**Millstone Nuclear Power Station, Unit No. 3
Response to Requests for Additional Information
Spent Fuel Pool Rerack (TAC No. MA5137)**

Response to Requests for Additional Information
Spent Fuel Pool Rerack (TAC No. MA5137)

Responses to Revised Draft RAI dated March 14, 2000

Responses to Draft RAI dated February 25, 2000

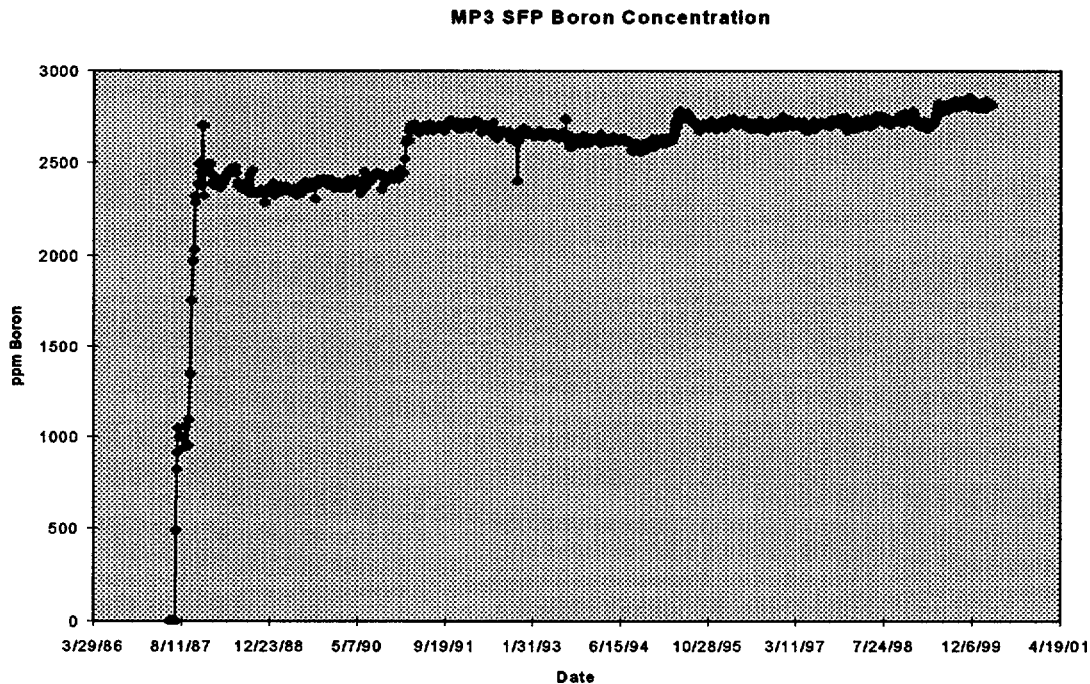
- 1. What will be the minimum and maximum boron concentrations in the spent fuel pool specified by chemical procedures if your submitted amendment is approved?**

NNECO will maintain the spent fuel pool (SFP) soluble boron concentration ≥ 2600 ppm at all times in accordance with chemistry procedures. This is done as a matter of operational convenience since the SFP boron concentration must be ≥ 2600 ppm during refuelings (per Technical Specification 3.9.1.1) when the SFP and refueling cavity are connected. A value of ≥ 2600 ppm is bounding on all Technical Specification (TS) requirements, including the proposed TS 3.9.1.2 as modified on April 17, 2000⁽¹⁾.

There is no specified maximum SFP boron concentration.

NNECO has historically maintained the SFP boron concentration at high values. The administrative limit of ≥ 2600 ppm was instituted in 1997. Shown below is a plot of Millstone Unit No. 3 SFP boron concentration measurements since the SFP water was initially borated in 1987:
